# ***Marsden Park Warehousing Estate***

*State Significant  
Development  
Modification Assessment  
(SSD 8606 MOD 2)*

September 2019

**Figure 3** | Modified Site Layout

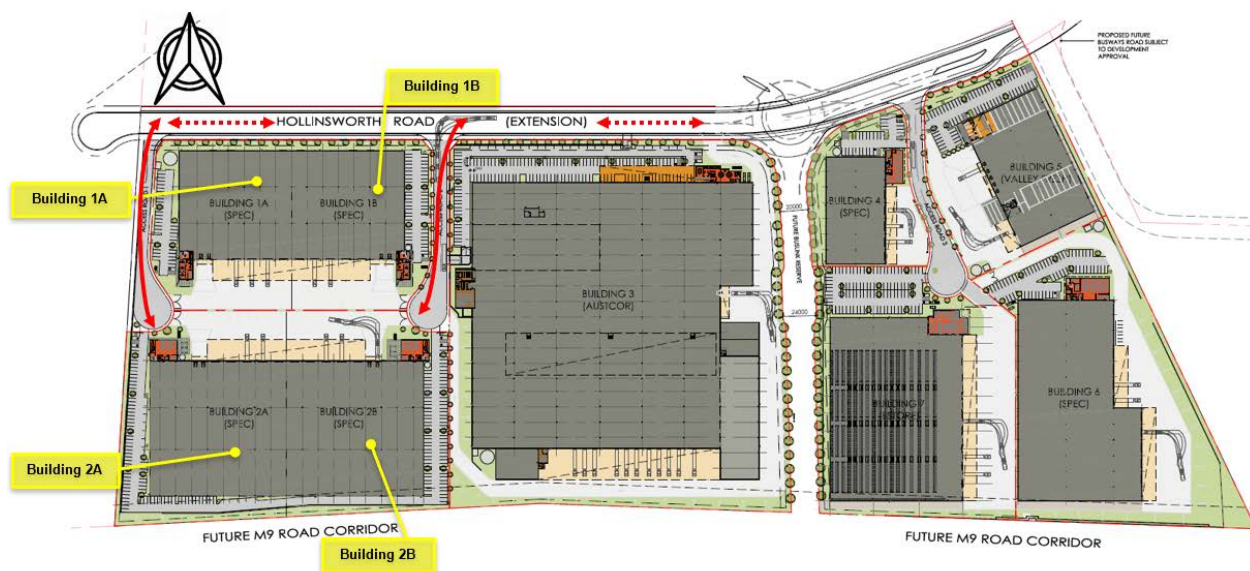
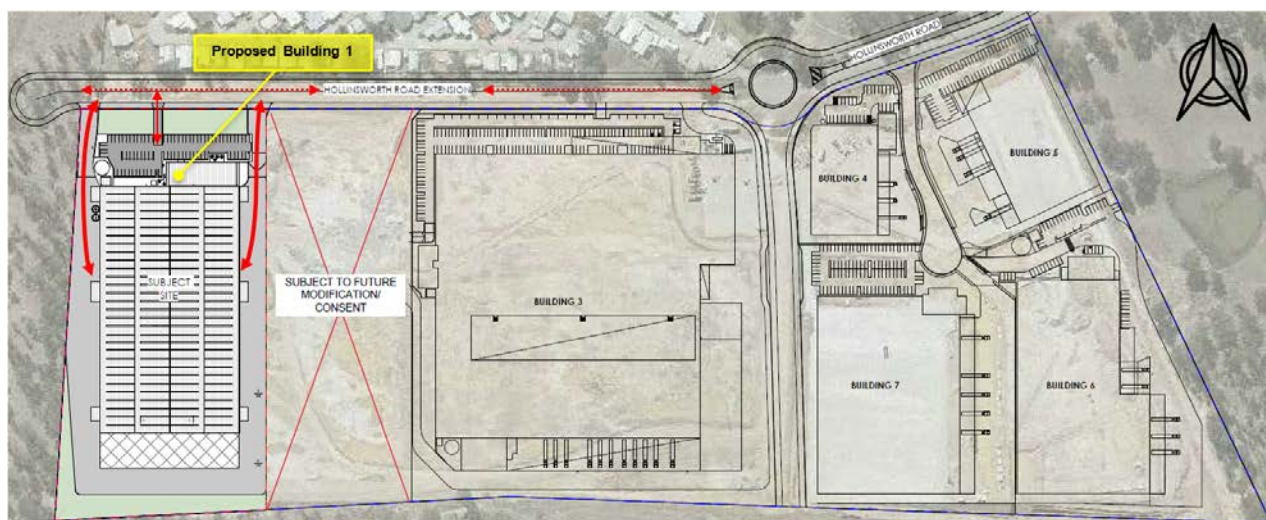
The Applicant has lodged an application under section 4.55(1A) of the EP&A Act to modify SSD 8606. The purpose of the application is to construct and operate a single building, in lieu of the previously approved buildings 1 and 2 contained in stage 4. As a result of the amalgamation of buildings, approximately 22,000m<sup>2</sup> of residual land will remain to the east of the proposed building (see **Figure 3**) for a potential future use on site.

The modification has been described in full in the Statement of Environmental Effects (SEE) included in **Appendix A** and is illustrated on **Figures 3** and **Figure 4** and summarised in **Table 3**. The modification involves:

- consolidation of tenancy 1A and 1B into one building and removal of tenancy 2A and 2B (summarised in **Table 2**)
- revised carpark layout and access arrangements
- inclusion of a specific development description relating to the proposed tenant for building 1, Orrcon Steel
- changes to Condition B30 – rainwater harvesting
- changes to Condition B36 – operation noise limits
- changes to Condition B45 – bushfire design provisions.

**Figure 4** | Proposed Building 1 Site Plan and Floor Plan

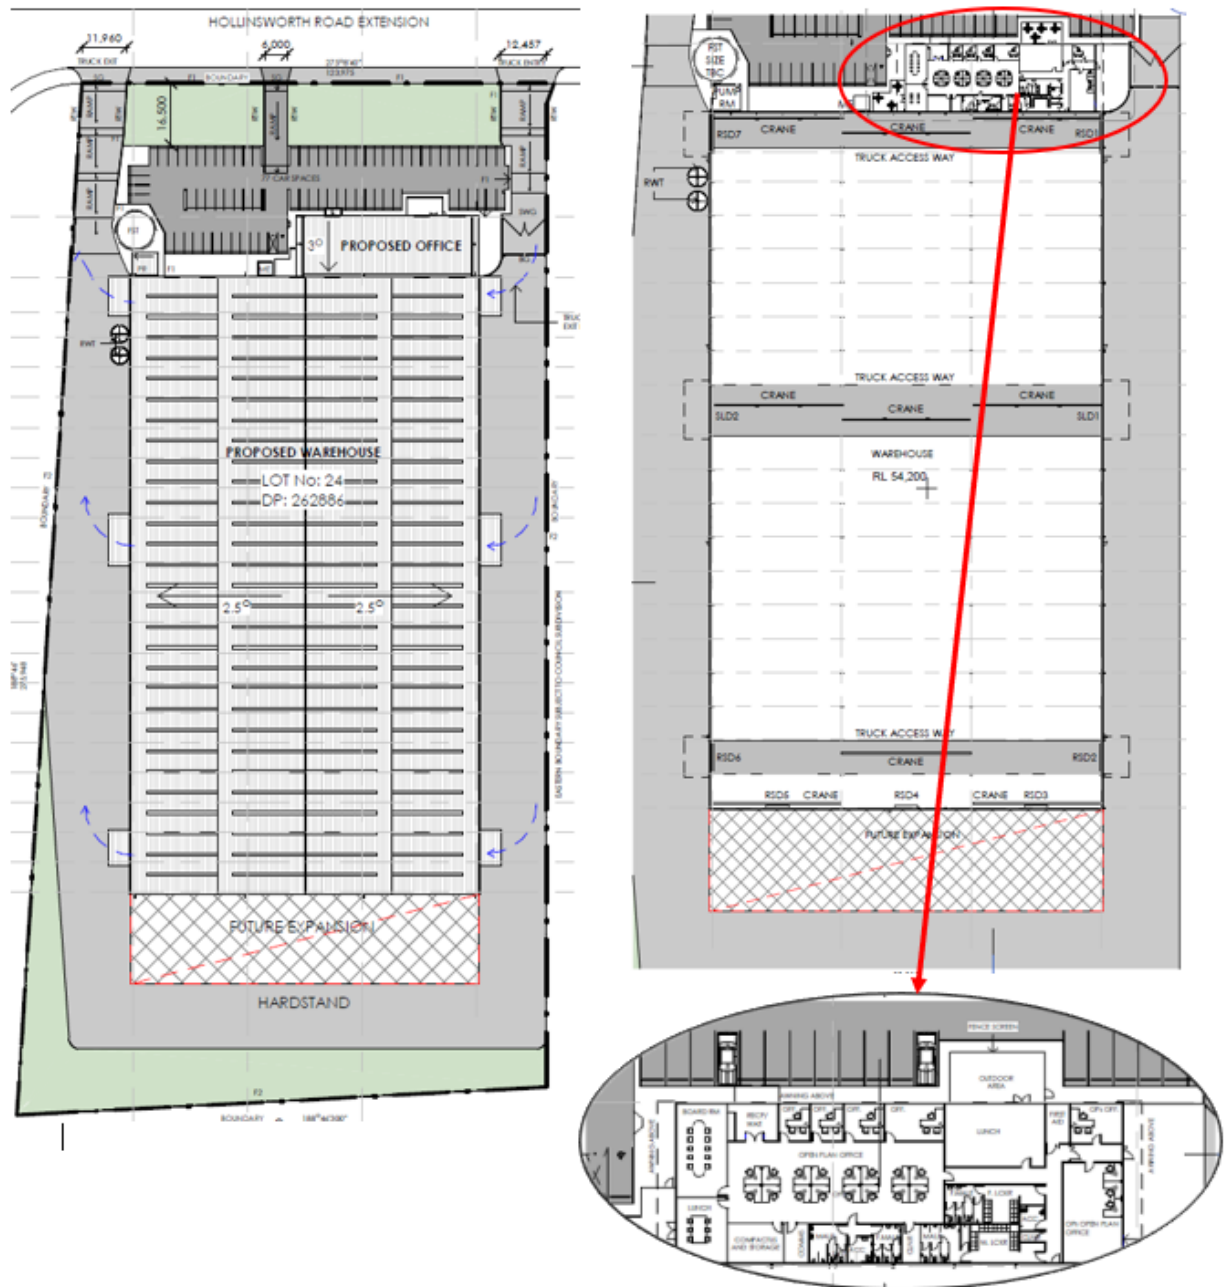
Modification Aspects	Approved (Buildings 1A, 1B, 2A & 2B)	Proposed (Building 1)
Office layout	Two-storey offices	One-storey office
Gross Floor Area (GFA)	34,200m <sup>2</sup>	18,128m <sup>2</sup>
Access and Carparking Layout	Two access roads and separate parking for the four tenancies	Two heavy rigid vehicle (HRV) access points and one passenger vehicle access point off Hollinsworth Drive
Carparking Provision	248 spaces (including a surplus of 87 spaces)	77 spaces (including a surplus of one space)
